INSTRUCTION TO SERVICE

ITS: 5910

SECTION:	294 Power Cables
WRITTEN BY:	Jermie Marasigan
SUBJECT:	Part A: Trim Rear crown panel and bracket to prevent contact on HV cables Part B: Inspect BAE accessory cables and cut back cable insulation to $\frac{3}{4}$ " if required

Figure 2: Rear roof crown panel and bracket trimming reference

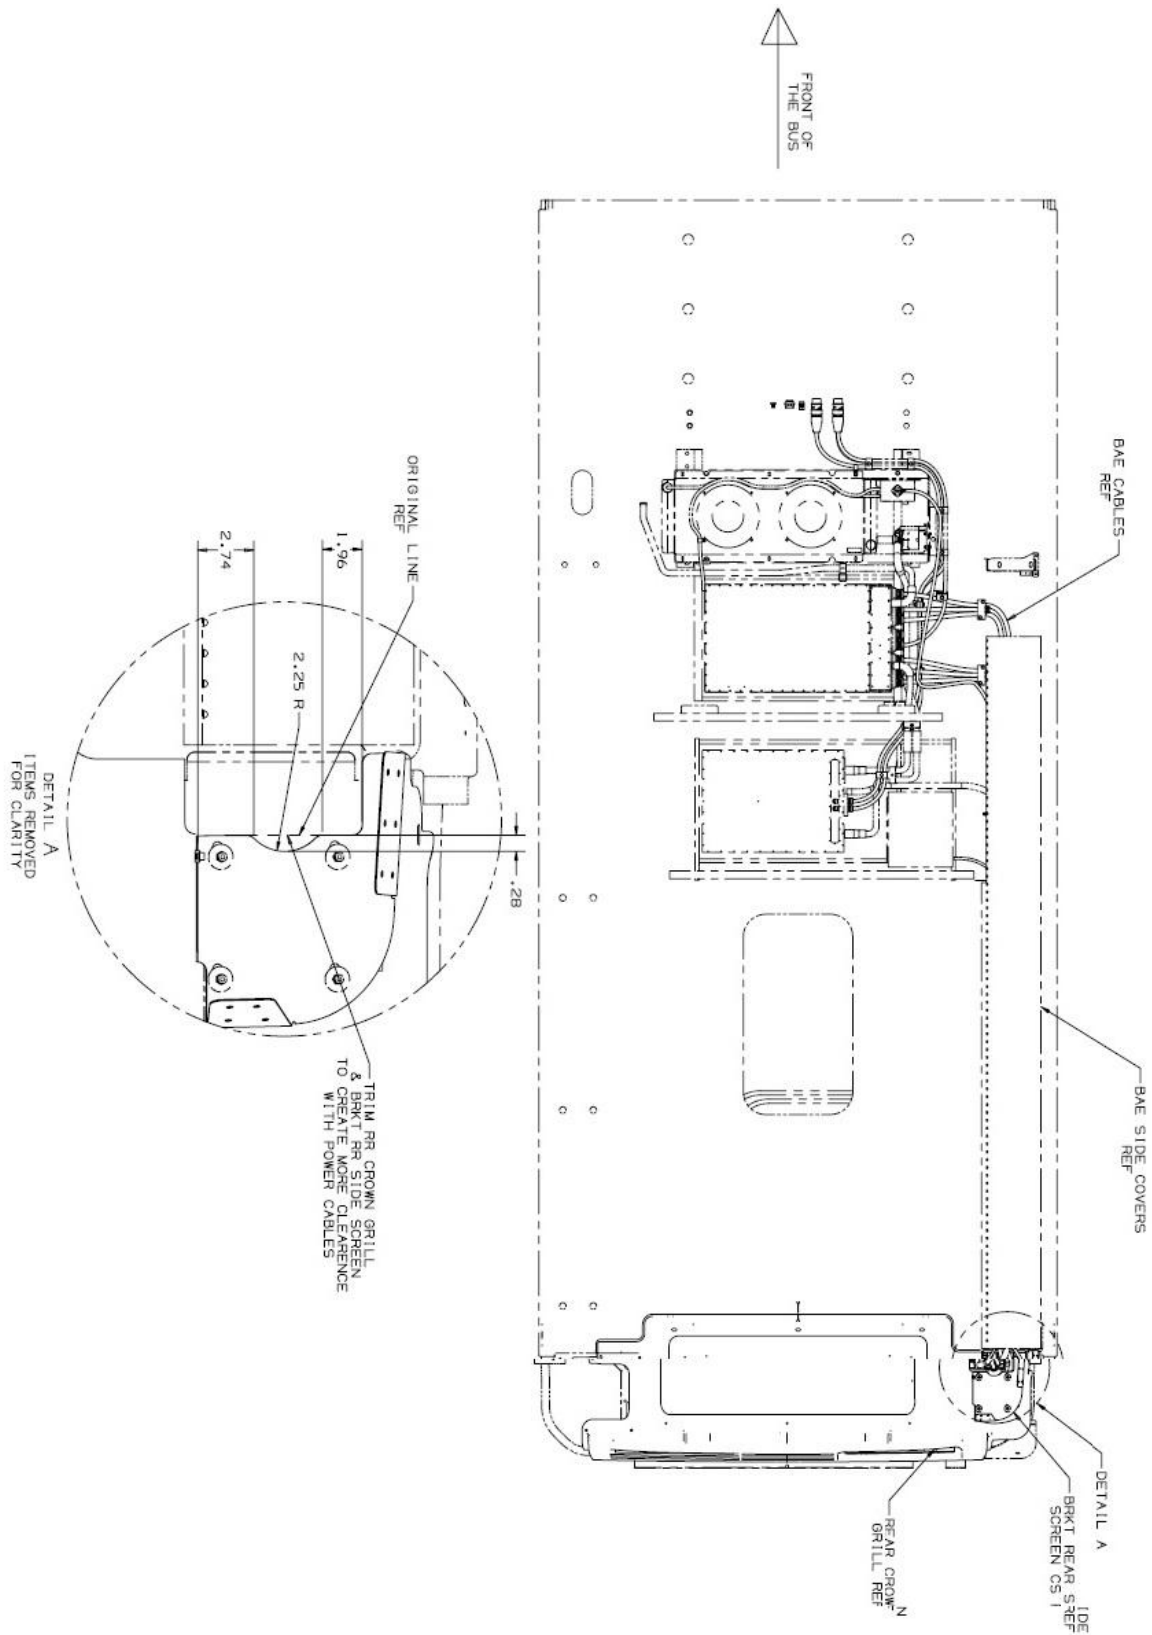
3. To prevent the HV cables from chafing, trim the roof crown panel and bracket as shown in Figure 2. Apply primer to the bracket after trimming.

Figure 4: Insulation Cut back reference

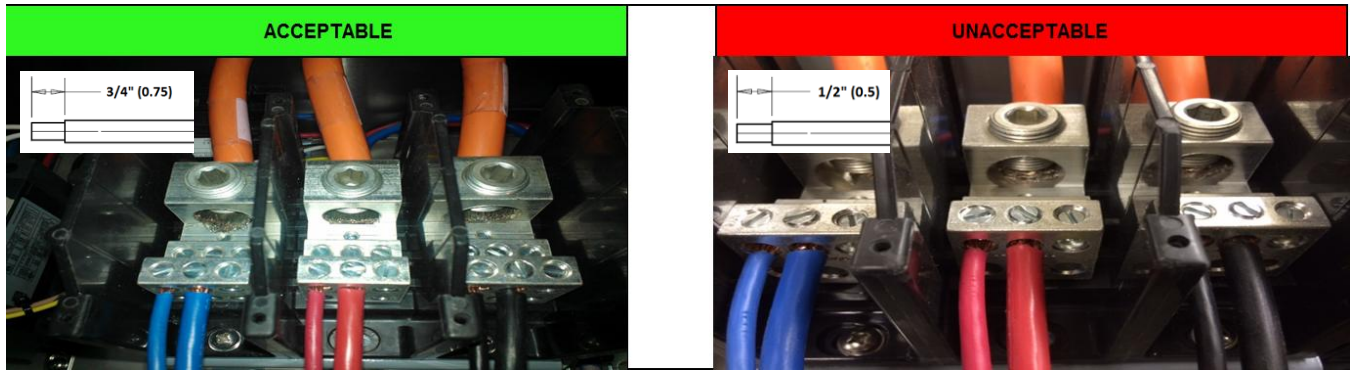
5. One at a time remove the BAE accessory cable and inspect if the cable insulation is cut back (stripped) to $\frac{3}{4}$ ". If the insulation is stripped less than $\frac{3}{4}$ ", cut back (strip) the insulation to $\frac{3}{4}$ ". See Figure 4 for reference. No need to rework the cable if the insulation is stripped $\frac{3}{4}$ ". Re-install the cable and torque line side to 32 Nm (275 in-lbs). Repeat this step on all three cables.
